SERVICE BULLETIN No.1148

COACH MODEL	: C2045
BULLETIN TYPE	: Service Information
MANUAL & SECTION	: Operator's Guide Book: Section 2 – Operating instructions Spare Parts Manual: Sections 782109, 783001 and 783009
PARTS BOOK REVISION	: No
DATE	: June 21st, 2005
SUBJECT	: Introduction to multiplex systems
TERMS & CONDITIONS	: No claims will be accepted with reference to this Bulletin.

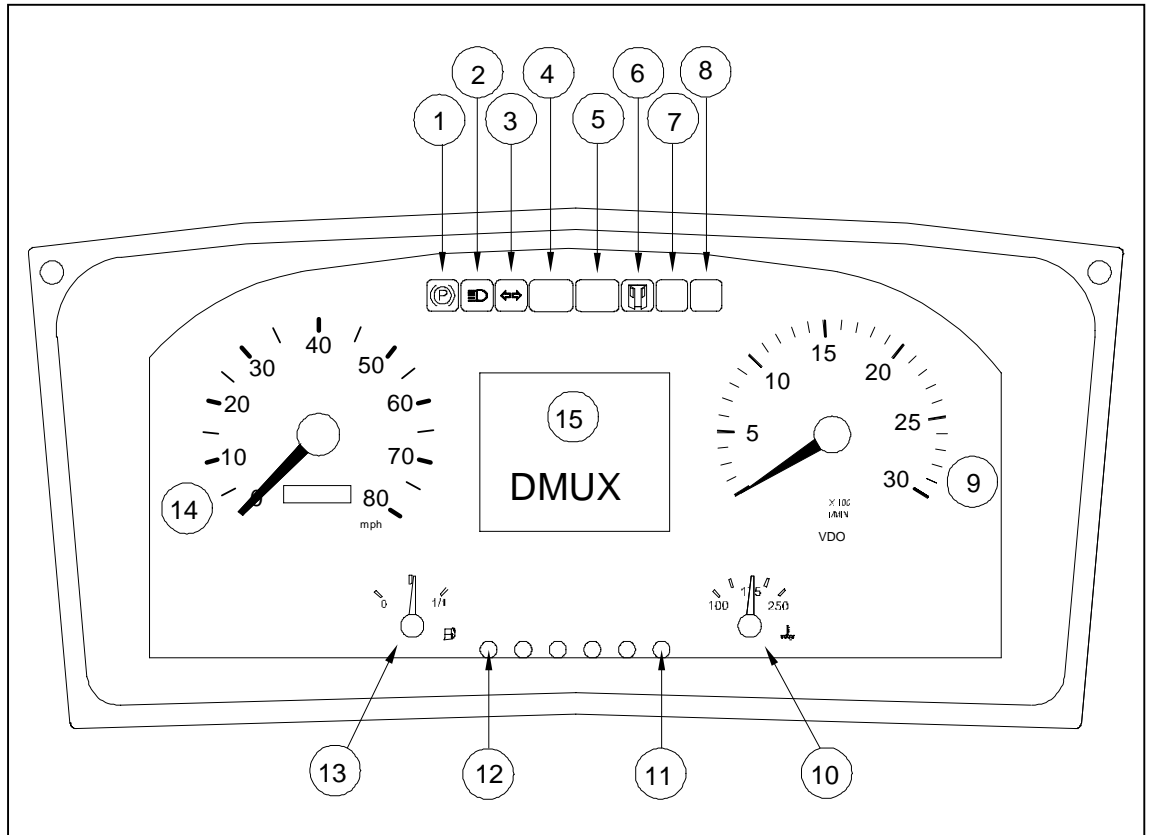
1. **Dash.** From the driver's seat, operators who have experience with the classic C2045 will notice a different center dash panel (see Figure 9).

Following changes have been made to the center section of the instrument panel:

- The speedometer and rev counter have switched places (9 and 14, Figure 9).

- The information given by the three axle air pressure gauges is now provided by the multifunction display (15, Figure 9) on a need-to-know basis or by pressing the MFD call-button once (12, Figure 9). Status is shown as a bar graph (see Figure 10) which disappears automatically after 10 seconds. Pressures are in psi units.

- The oil pressure gauge has been omitted. Oil pressure information is also provided by the MFD on a need-to-know basis (oil can shown in center of display, see Figure 11.1), or by pressing the MFD call-button (12, Figure 9) four times to obtain the actual operating pressure (Figure 11.2).

- The turbo boost gauge too has been deleted. This information is again provided by the multifunction display (see Figure 12) and can be retrieved by pressing the MFD call-button (12, Figure 9) three times. End of scale equals 2 bar (29 psi).

- The warning lamps in the center of the classic dash have been replaced by symbols and/or plain text on the multifunction display and by a single row of warning lamps (positions 1 through 8, Figure 9) which may or may not illuminate in conjunction with these symbols.

- A rheostat (11, Figure 9) allows the driver to change the light intensity of the dash.
 - With the introduction of the MFD as source of information, the warning lamp test switch has been omitted.
2. **Buzzer.** A buzzer has been installed, which can sound 4 different alarms (with engine running). These alarms may, or may not, sound in conjunction with the red or the amber warning lamp.

Figure 13: Transmission fluid temperature shown on MFD (no reading)

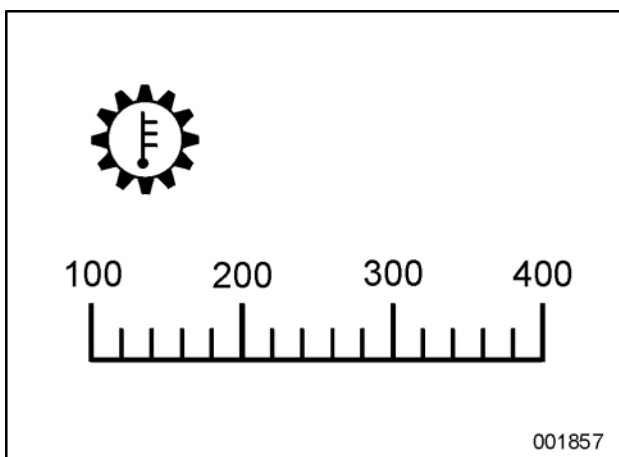
- New is the information on the temperature of the transmission fluid (see Figure 13). Press button 12, Figure 9 twice to have this information shown on the MFD.

Figure 14: Multiplexed C2045 buzzer signals

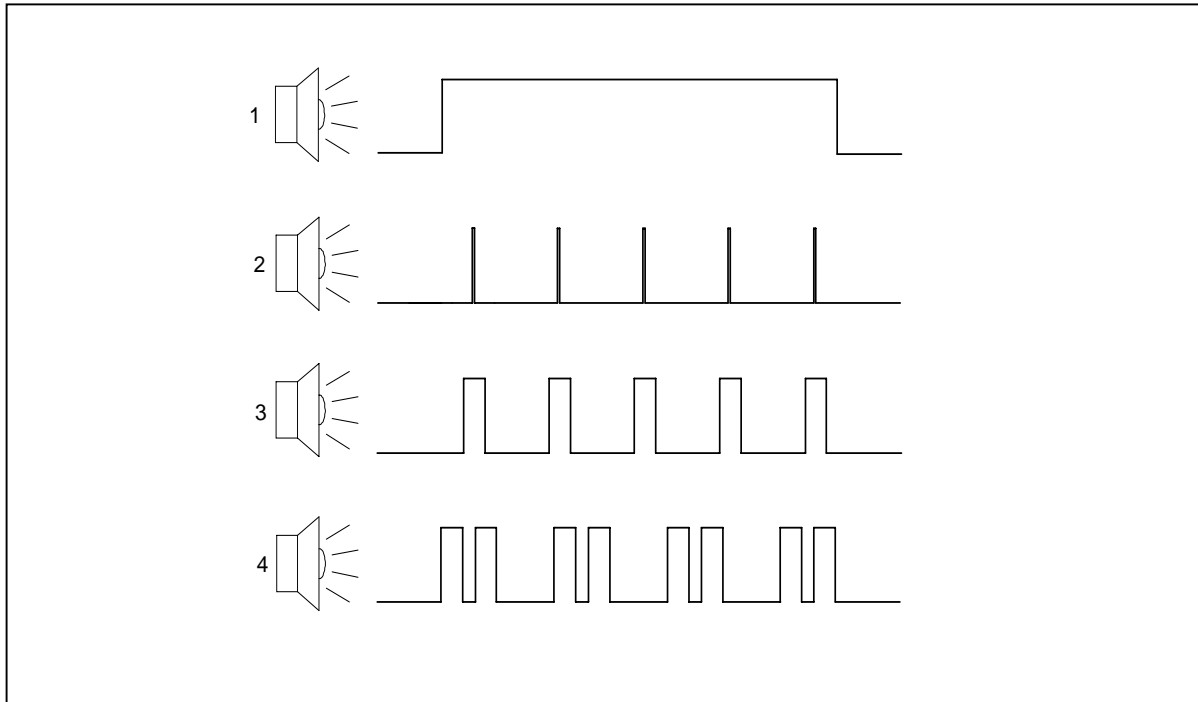
Buzzer signal	Key	Warning lamp
Continuous (1, Figure 14)	<ul style="list-style-type: none"> • Stop engine • Suspension rising/lowering/kneeling/rear raising • Passenger emergency call 	<ul style="list-style-type: none"> • Red • Amber
Spike pulse (2, Figure 14)	<ul style="list-style-type: none"> • Check engine/Engine warning • Fuel low • Do not shift 	<ul style="list-style-type: none"> • Amber • Amber • Amber
Single pulse (3, Figure 14)	<ul style="list-style-type: none"> • Transmission fluid temperature high • Fire alarm • Lift door unlocked 	<ul style="list-style-type: none"> • Red • Red
Twin pulse (4, Figure 14)	<ul style="list-style-type: none"> • Air system pressure low • Air pressure low at front/drive/tag axle 	<ul style="list-style-type: none"> • Red • Red
